Product/Process Change Notice (PCN)

PCN Number: PCN_FrqXTAL_20250303 Affected Series: WE-XTAL Affected Part Number: See table below PCN Date: 2024-12-03 Effective Date: 2025-03-03	Change Category: <input type="checkbox"/> Equipment/Location <input checked="" type="checkbox"/> General Data <input type="checkbox"/> Material <input type="checkbox"/> Process <input type="checkbox"/> Product Design <input type="checkbox"/> Shipping/Packaging <input type="checkbox"/> Supplier <input type="checkbox"/> Software																				
Contact: Product Management Phone: +49 (0) 7942 - 945 5001 Fax: +49 (0) 7942 - 945 5179 E-Mail: pcn.eisos@we-online.com	Datasheet Change: <input checked="" type="checkbox"/> Yes <input type="checkbox"/> No Attachment: <input type="checkbox"/> Yes <input checked="" type="checkbox"/> No																				
DESCRIPTION OF CHANGE: <p>Because of a database mismatch, Würth Elektronik eiSos will correct the RoHS status (1), IQD Part No. format (2), product dimensions (3), solder pad layout (4) environmental parameters (5) and packaging details (6) in the datasheet. This is a datasheet correction only. There will be no change in form, fit, function, quality or reliabili

4. Correction of the Solder Pad Layout:

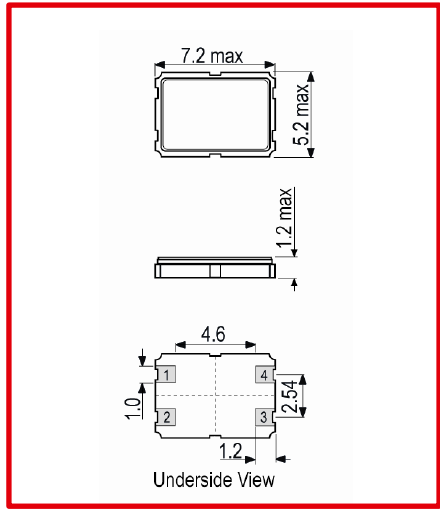
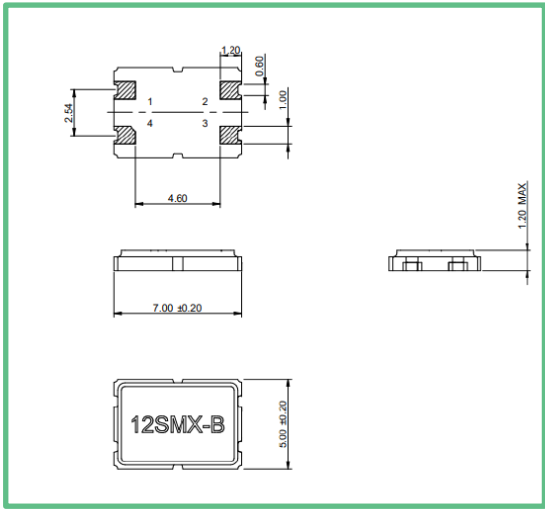
Before	After
Solder Pad Layout
